Warranty Bulletin

95-24

Date: **July 1995**
Section: **12**
Subject: **WET AND PRIMARY AIR TANKS SUPPORTS**
Application:

FIGURE 1

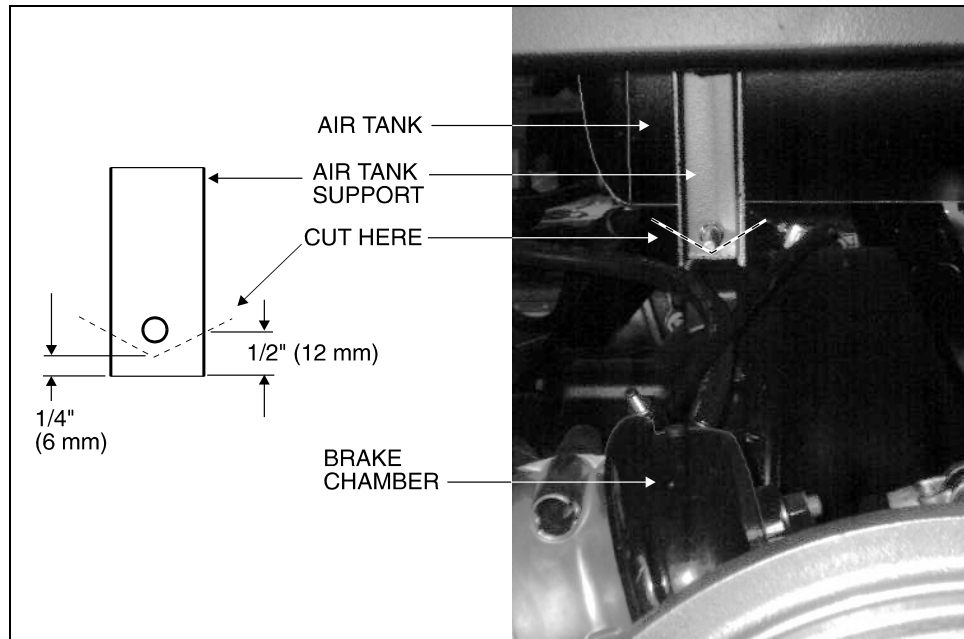
On the above mentioned vehicles, the wet and primary air tanks supports could interfere with drive axle brake chambers when the suspension is at its lowest position. To prevent possible damage to the brake chambers, you must modify the air tank support according to the following procedure.

1. Under vehicle, over drive axle brake chambers (L.H. and R.H. sides), locate the air tanks supports (Fig. 1).
2. Cut the extremity of each support, located right over brake chamber, under stud and nut (Fig. 1).

Caution: Do not use a torch to cut support.

3. Check drive axle brake chambers for dents or leaks caused by air tank supports. If dents or leaks are detected on a brake chamber, it must be replaced.
